APPENDIX 3 ATTACHMENT 1

ILUKA STRUCTURE PLAN

Structure Plan No. 26

Record of Amendments made to the Iluka Structure Plan

PROPOSED LOCAL DEVELOPMENT PLANS

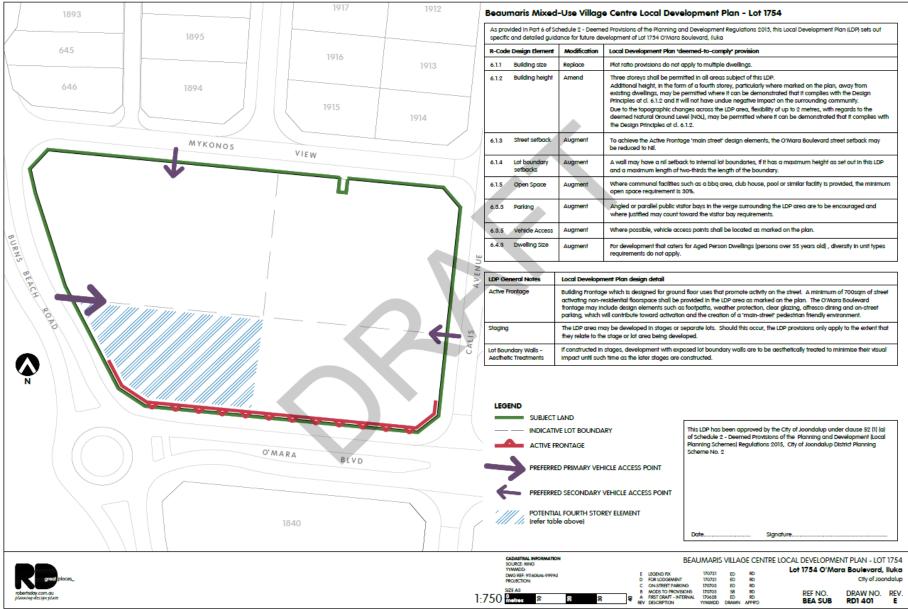
Land use permissibility and general provisions shall be the same as those within the Residential zone under the scheme unless otherwise specified in the Structure Plan. <u>1. Removal of Centre Zone, replaced with Commercial</u>	,	
	Land use permissibility and general provisions shall be the same as those within the Residential zone under the scheme unless otherwise specified in the Structure Plan. <u>1. Removal of Centre Zone, replaced with Commercial</u> <u>R60 Zoning.</u>	,	
	Land use permissibility and general provisions shall be the same as those within the Residential zone under the scheme unless otherwise specified in the Structure Plan. <u>1. Removal of Centre Zone, replaced with Commercial R60 Zoning.</u> <u>2. Requirement for Local Development Plans for Village</u>	,
